APPLICATION FOR CERTIFICATE OF APPROPRIATENESS HISTORIC CONSERVATION BOARD PUBLIC HEARING STAFF REPORT

APPLICATION #: COA2018044
APPLICANT: Dale Doyle & Carissa Barnard
OWNER: Dale Doyle & Carissa L. Barnard
ADDRESS: **207 E. Clifton Avenue**
PARCELS: 094-0007-0273
ZONING: RM-0.7
OVERLAYS: Over-the-Rhine Historic District
COMMUNITY: Over-the-Rhine
REPORT DATE: July 30, 2018
HEARING DATE: August 20, 2018
STAFF REVIEW: Douglas Owen, Zoning Plan Examiner

- A100 COVER
- A101 DECK PLAN - 4TH FLOOR
- A102 BIRD'S EYE VIEW
- A103 ELEVATIONS

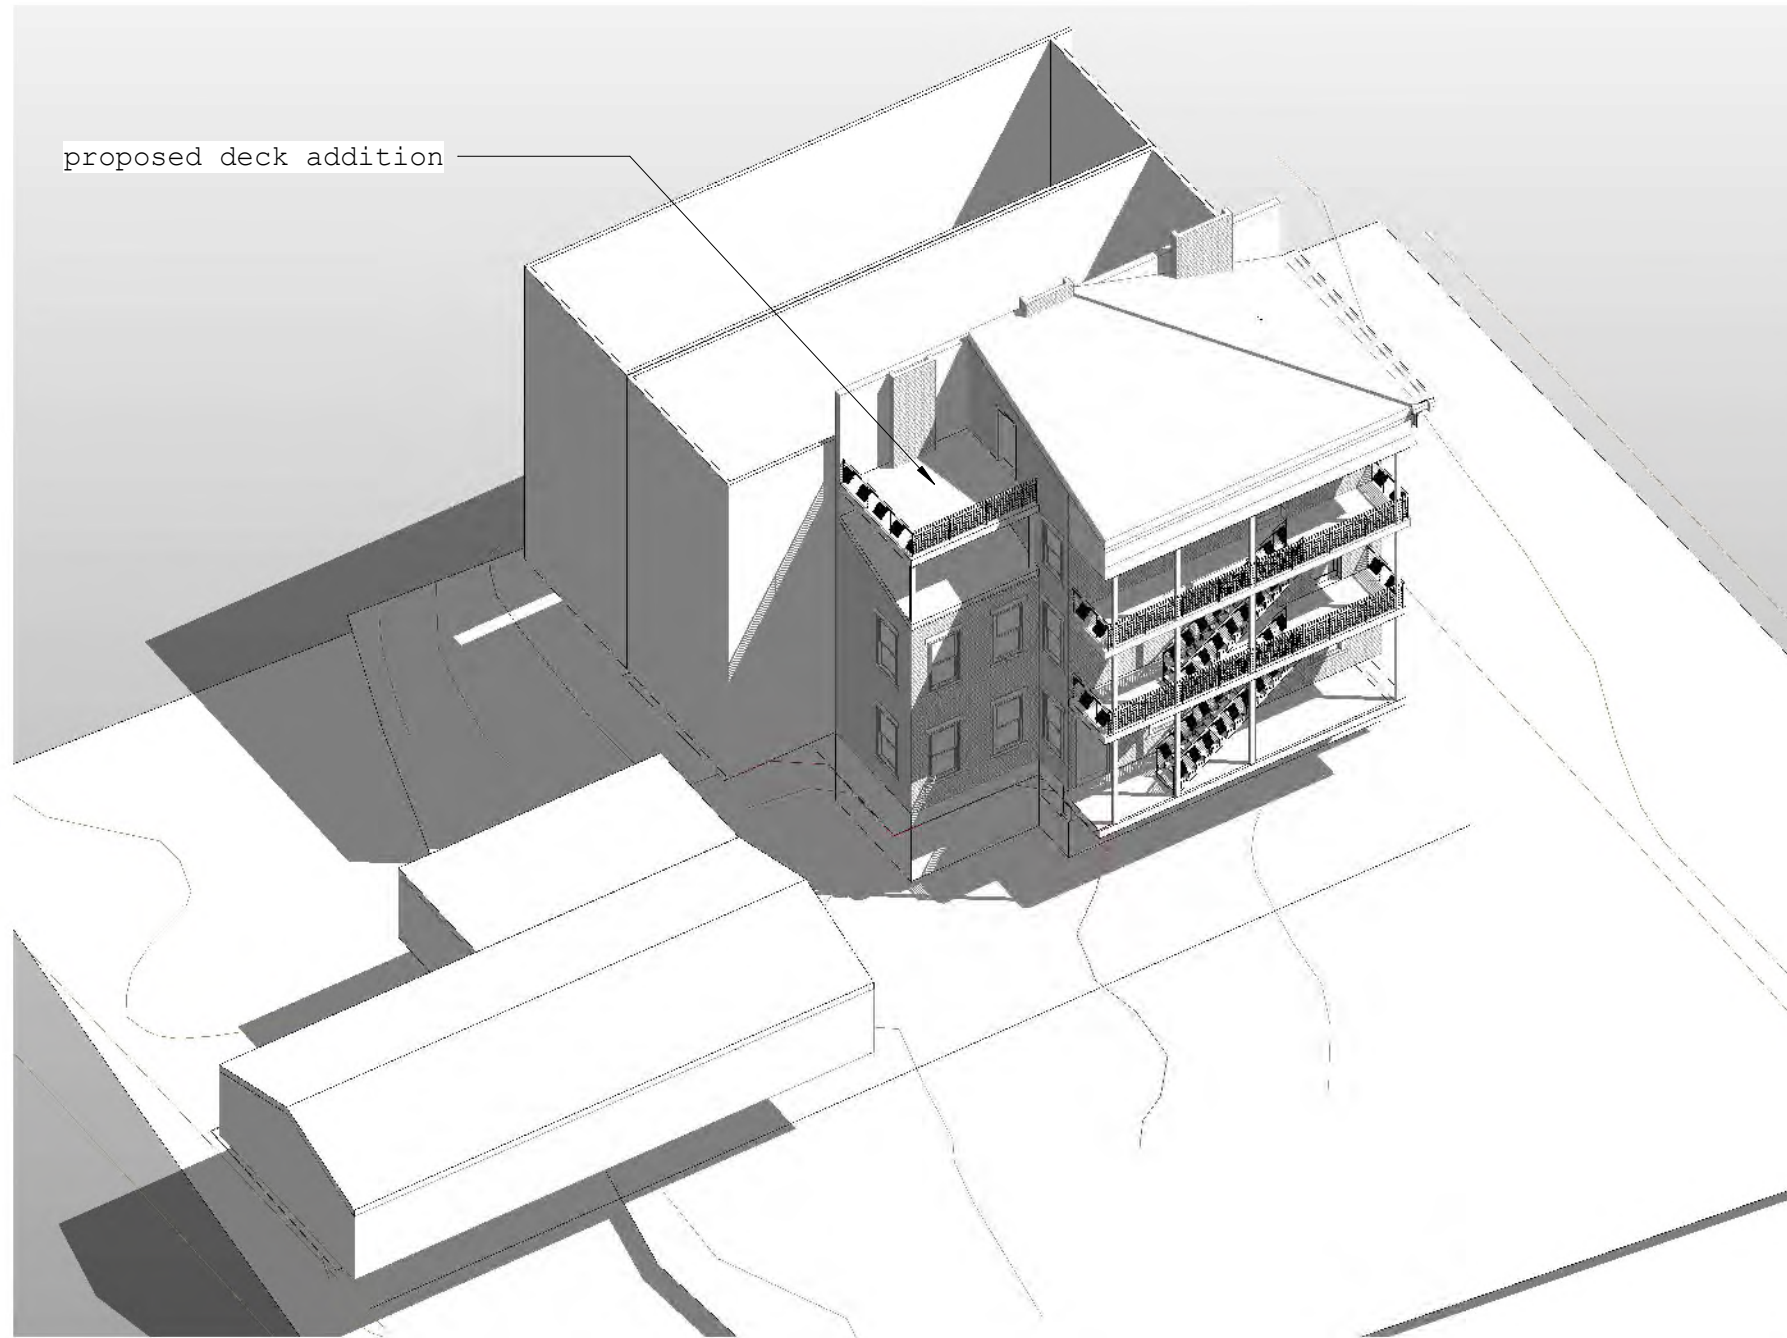
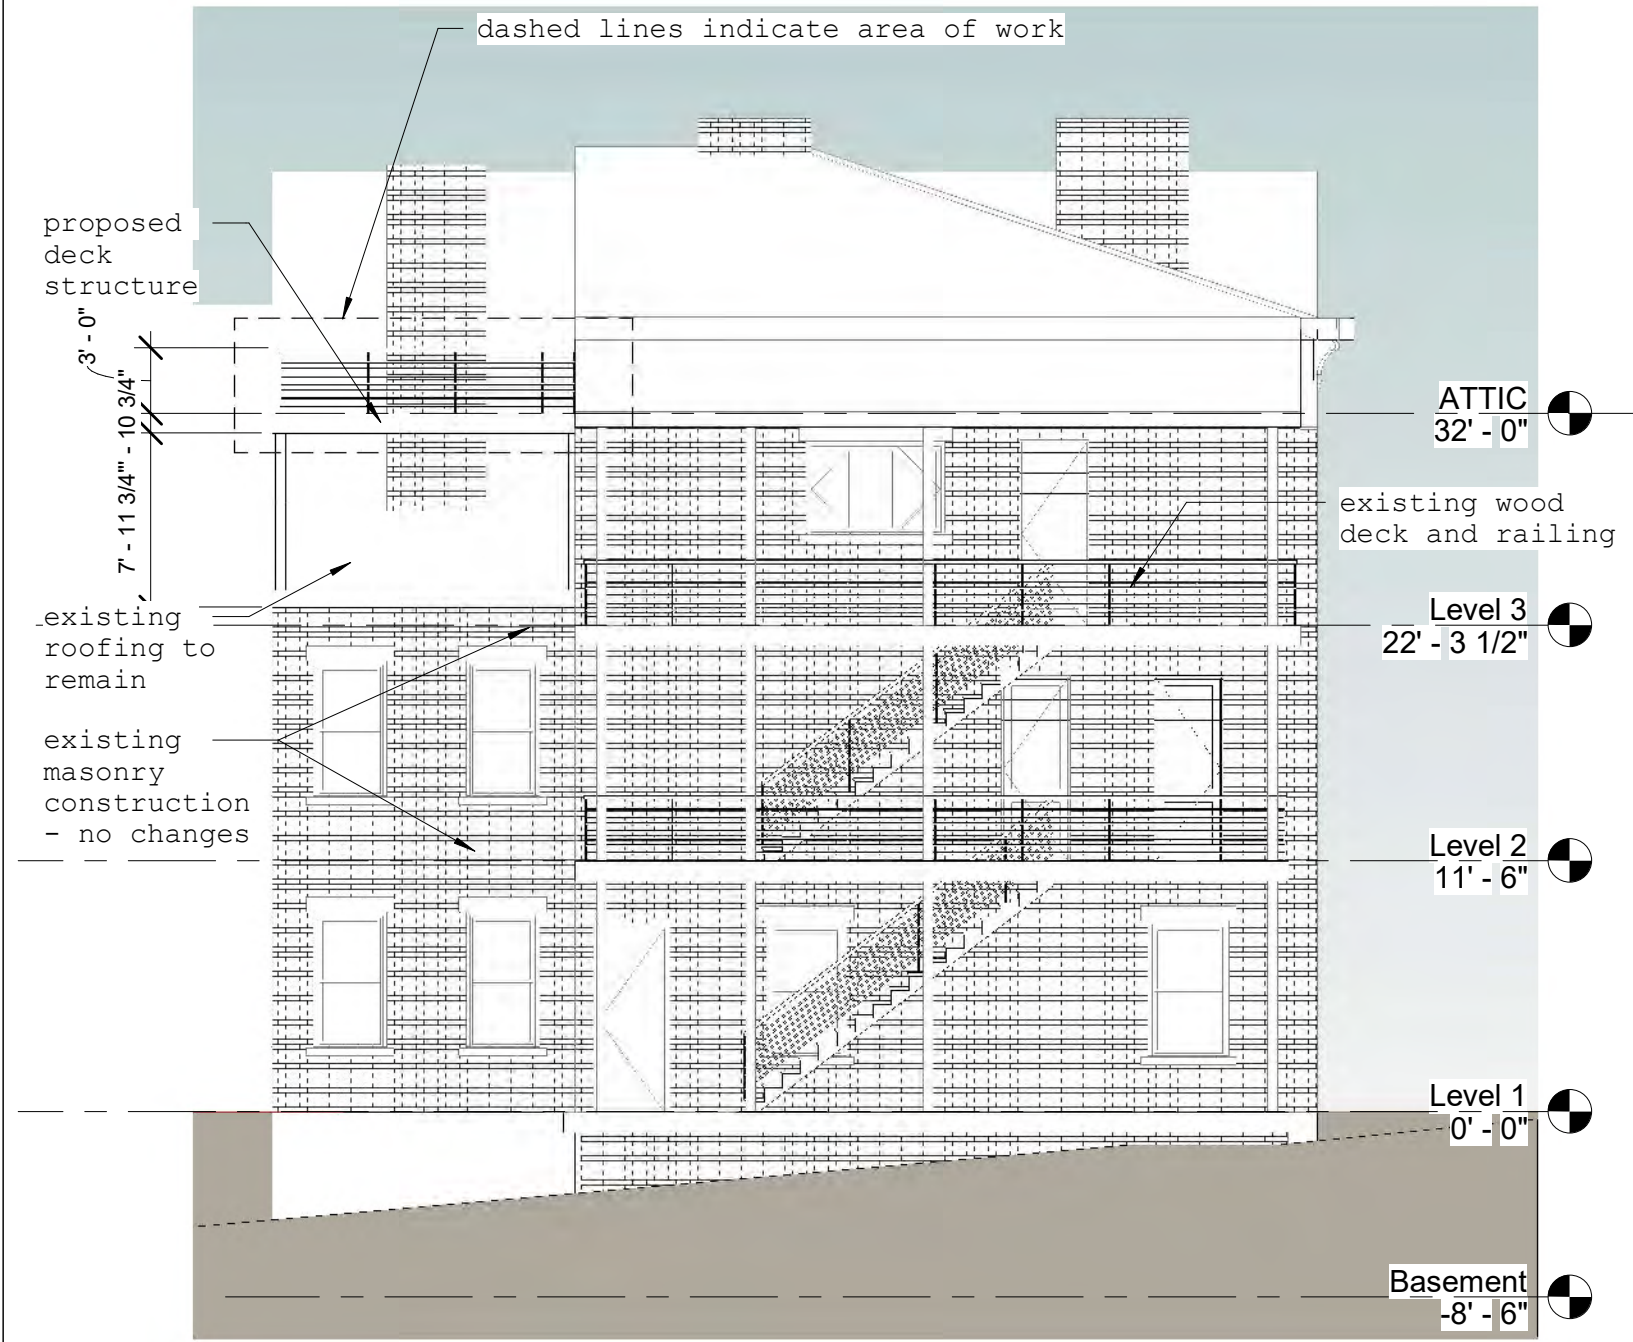
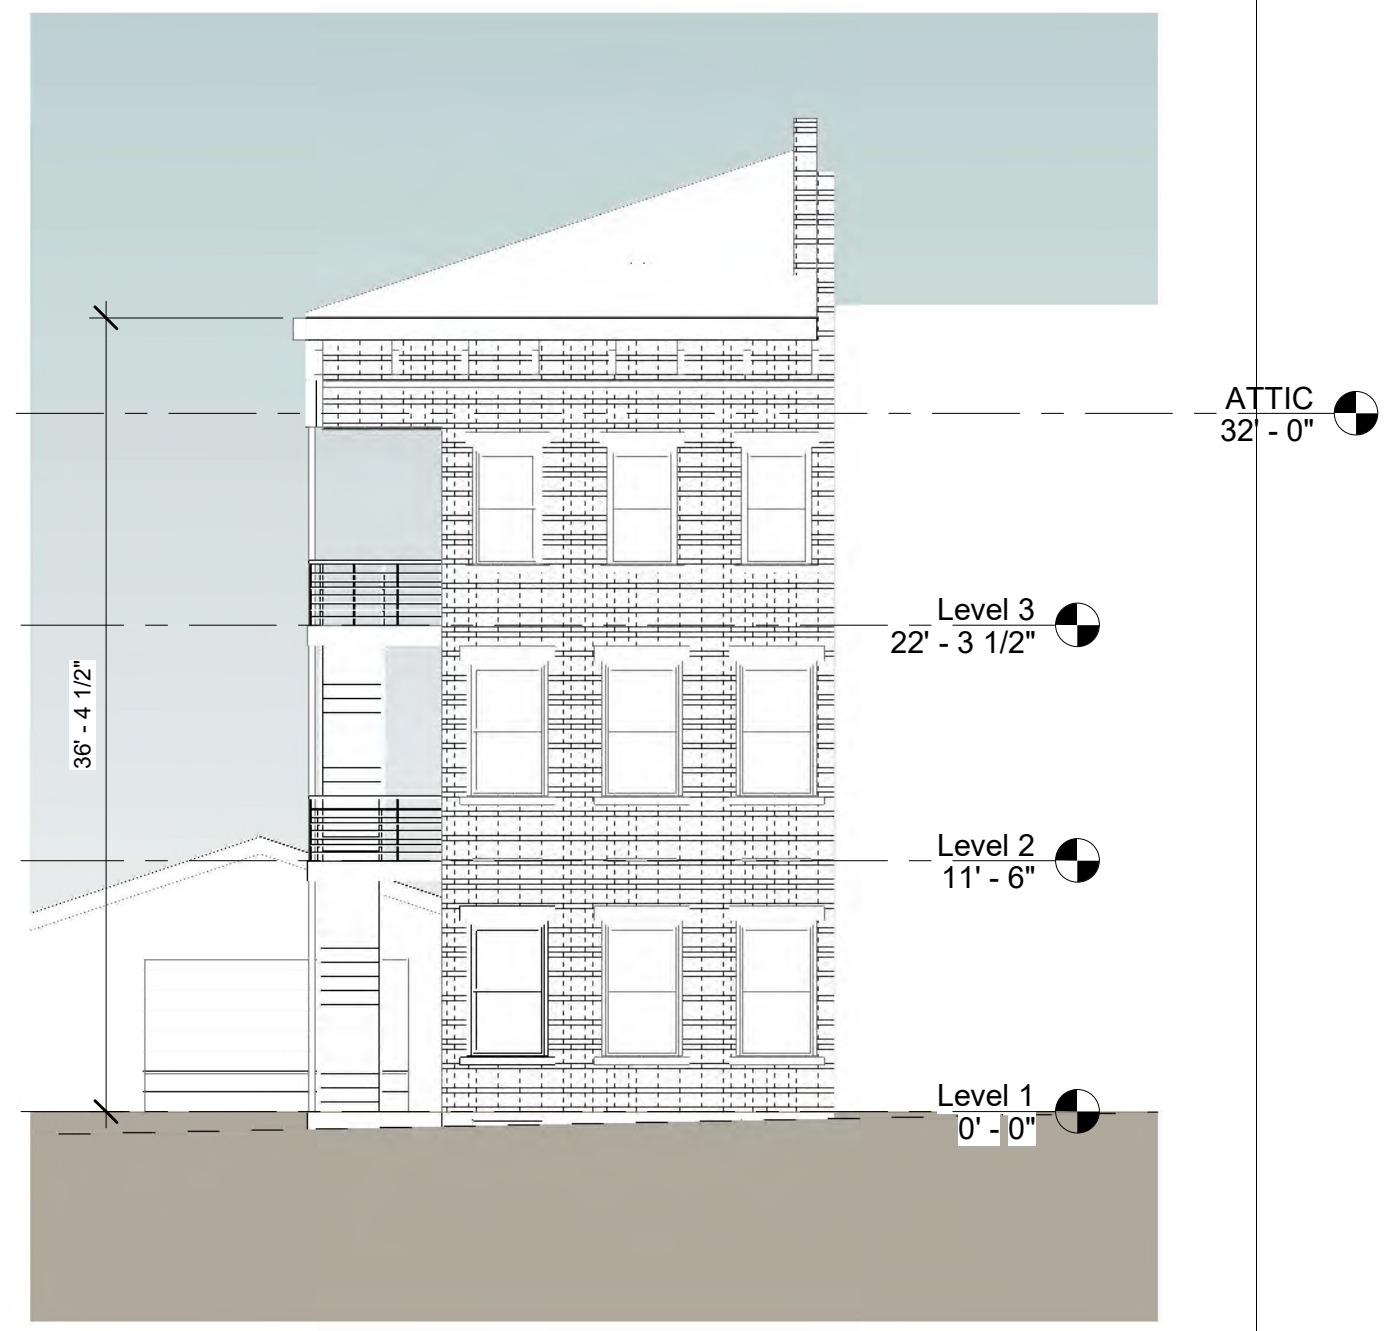
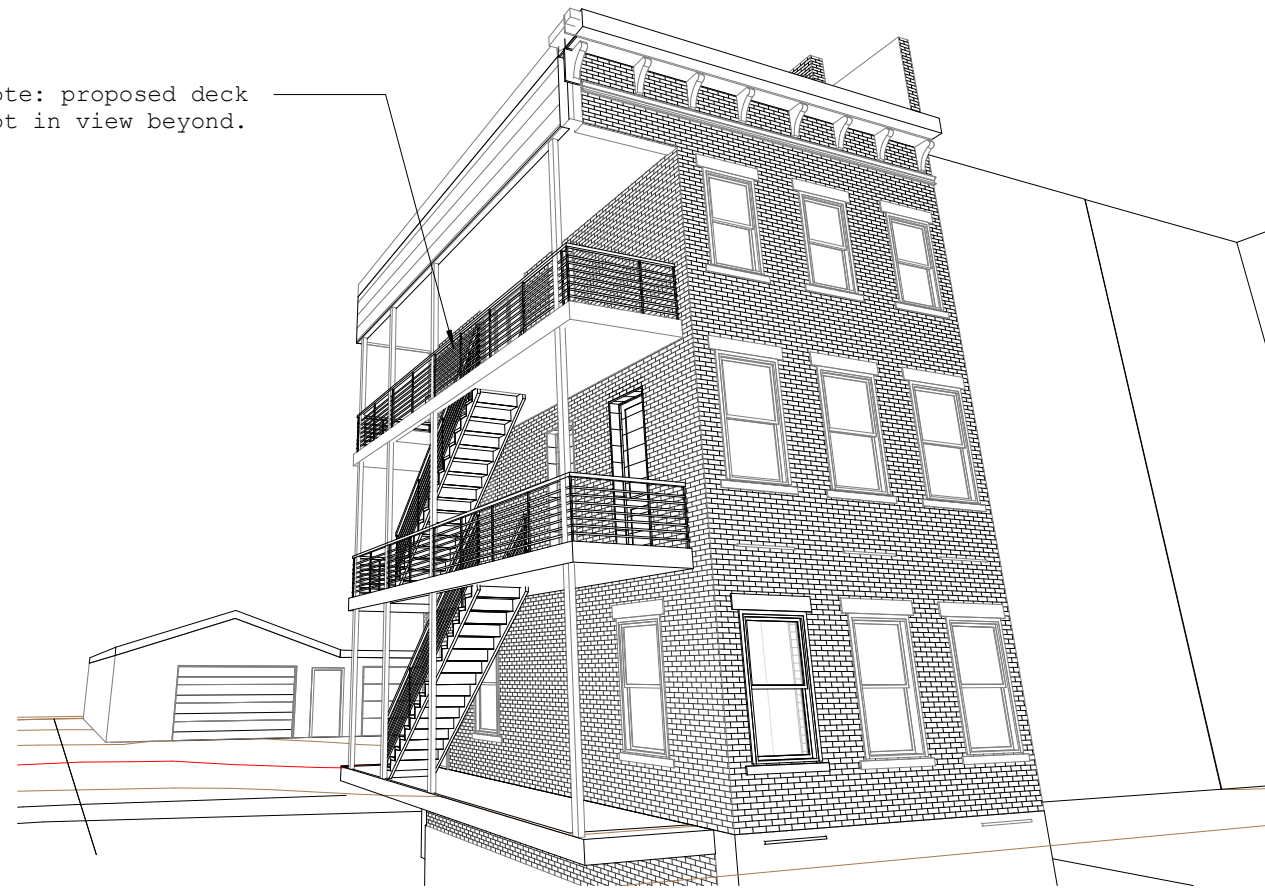
A Certificate of Appropriateness is required for the construction of the deck. The applicant stated that the deck would be fully supported on the subject property and would not be anchored into the adjacent building at 205 E. Clifton. This should be clearly demonstrated on construction drawings submitted for permitting as required by the building code.

Staff feels the proposed rehabilitation is generally appropriate in the Over-the-Rhine Historic District. The rehabilitation retains the existing historic structures and will simply expand the outdoor living area of the residence. The addition of the wood deck will not detract from the character-defining features of the property. While the deck will be placed above the existing roof of the building's rear wing, the roof will remain intact.

The wood deck proposed for the property will be of a compatible scale with the surrounding architecture. All wood will be stained and the steel and cable railing is contemporary and compatible and will not distract from the character defining features of the adjacent properties. The deck will not be visible when viewed from directly in front of the property, but will be visible when viewed from an angle from the east of the property. This visibility is due to the adjacent playground serving the Rothberg School. The deck will be minimally intrusive and is compatible with the primarily residential nature of the area. Staff feels the proposed deck is in character with the contributing buildings in the district and is appropriate in colors, textures, materials, and scale.

- A. **APPROVE** a Certificate of Appropriateness for 207 E. Clifton Avenue per plans by Eric C. Puryear Architect dated 5.30.2018 including any revisions submitted for permit subject to staff review and approval with the following condition:
 1. Consolidation Plat is required to combine Parcels 094-0007-0273, 094-0007-0274 and 094-0007-0351
 2. The building permits must be issued within two years of the decision date or the Certificate of Appropriateness shall expire.
- B. **FINDING:** The Board makes this determination per Section 1435-09-2:
 2. That the property owner has demonstrated by credible evidence that the proposal substantially conforms to the applicable conservation guidelines.

PROPORTION

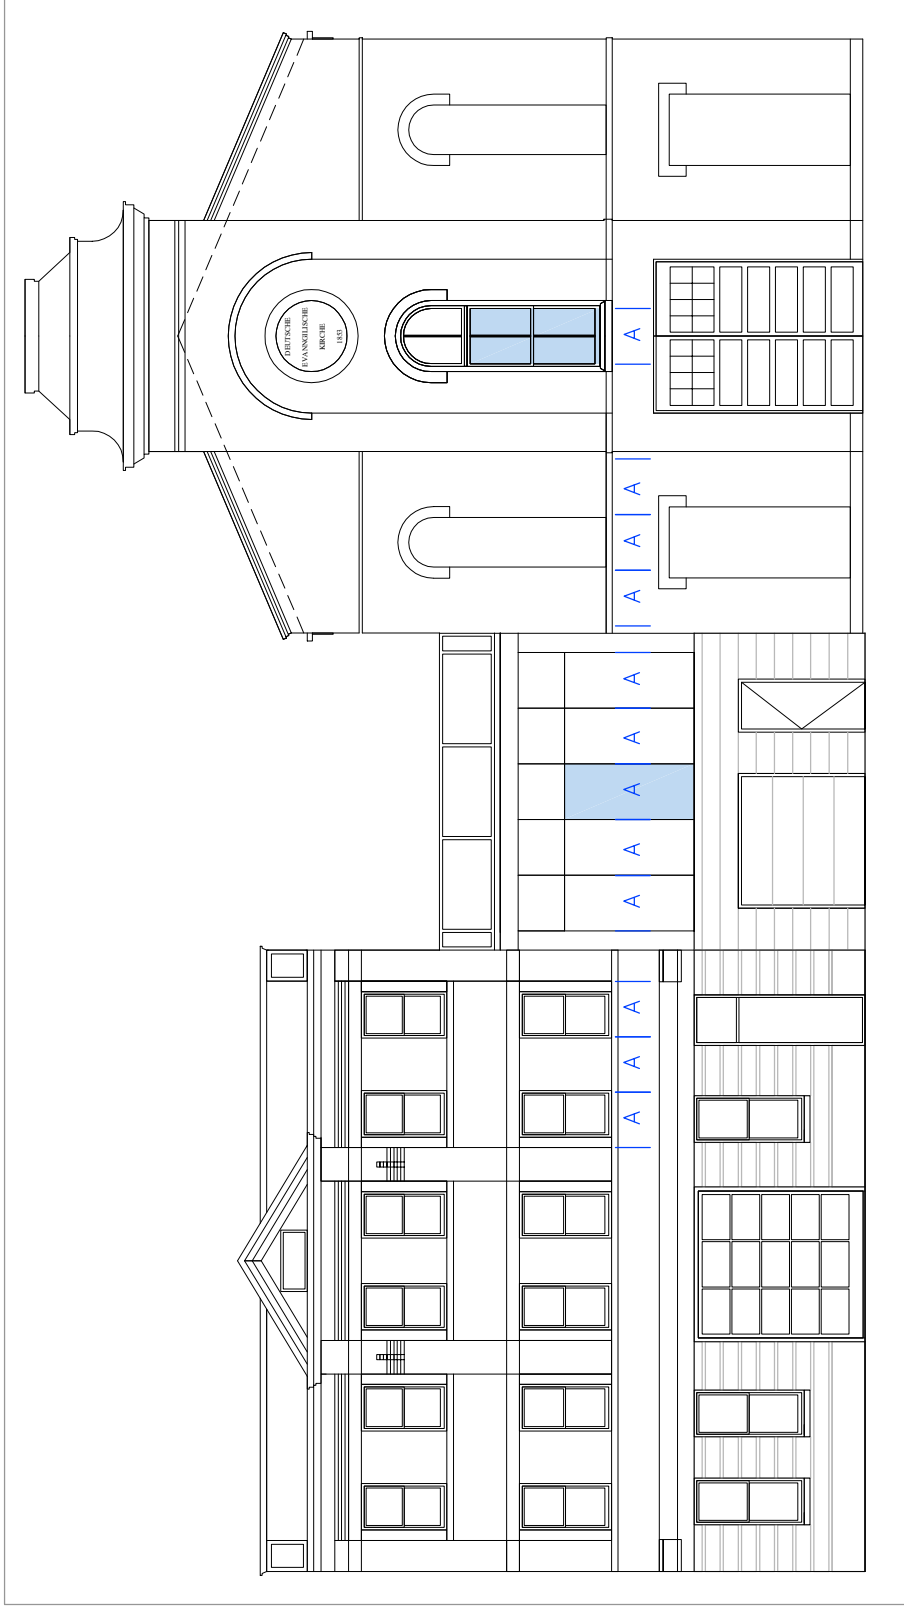
Figure 4: Proposal of permanent tinting 2 of the 5 panels to create a reference to punched openings.
